Project: Old Trail Village Blocks 5, 20 & 21 –Initial Site Plan
Plan preparer: Justin Shimp, Shimp Engineering, 201 E. Main St.
Suite M, Charlottesville, VA 22902 [justin@shimp-engineering.com]
Owner or rep.: March Mountain Properties LLC [1005 Heathercroft Circle, Suite 100]
Dave Brockman, dave@oldtrailvillage.com
Plan received date: 7 Jun 2016
Date of comments: 7 Jul 2016
Reviewer: John Anderson (*for Engineering*)
Project Coordinator: Johnathan Newberry

SDP2016-00033

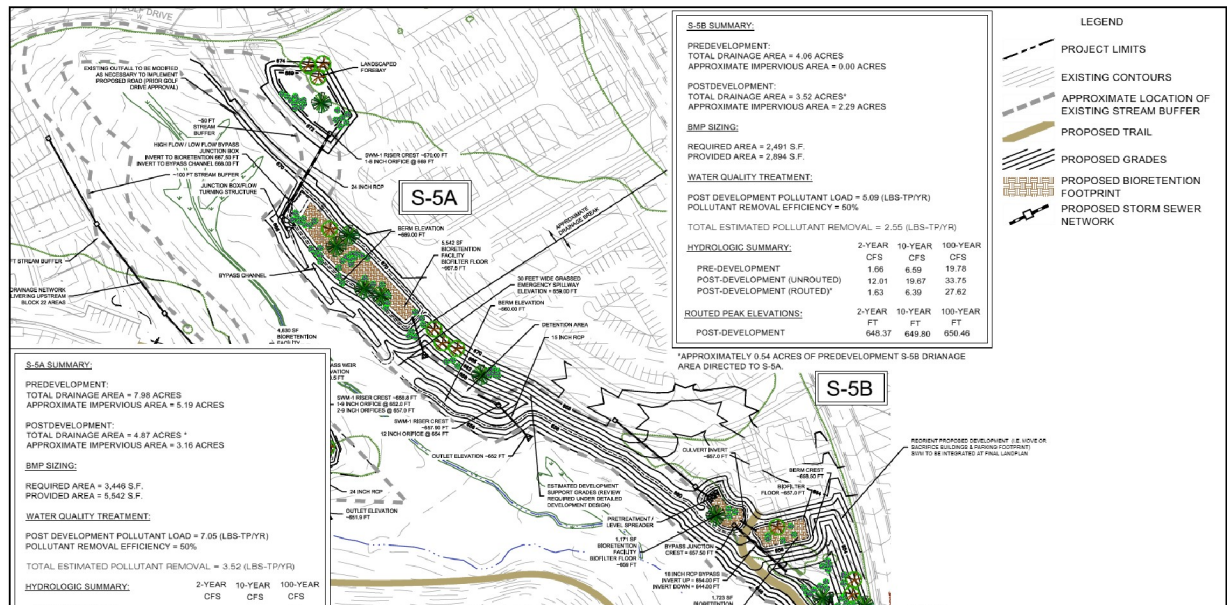
1. Conceptual SWM design is inconsistent with Old Trail Village Stormwater Master Plan accepted as a development-wide SWM compliance document, 25-Apr 2016. Conceptual SWM presented with Initial Site Plan appears to propose higher impervious areas relative to DA routed to SWM facilities than shown on Fig. 18, SWM facilities S-5A, S-5B (Fig. 18, OTV SW MP), and proposes underground detention for post-developed runoff with release *without* water quality treatment for certain areas of the development, inconsistent with Apr 2016 SW Master Plan. Initial Site Plan takes slight measure of Master Plan concepts or expectations. Engineering and Planning shared concerns with Applicant during and following a pre-Application meeting on 25-Apr 2016. See email, Megan Yaniglos to Justin Shimp, bullet #4 (Tue 4/26/2016 9:42 AM). Ref. image below. Ref. Old Trail Village Stormwater Master Plan. Contact reviewer to discuss.
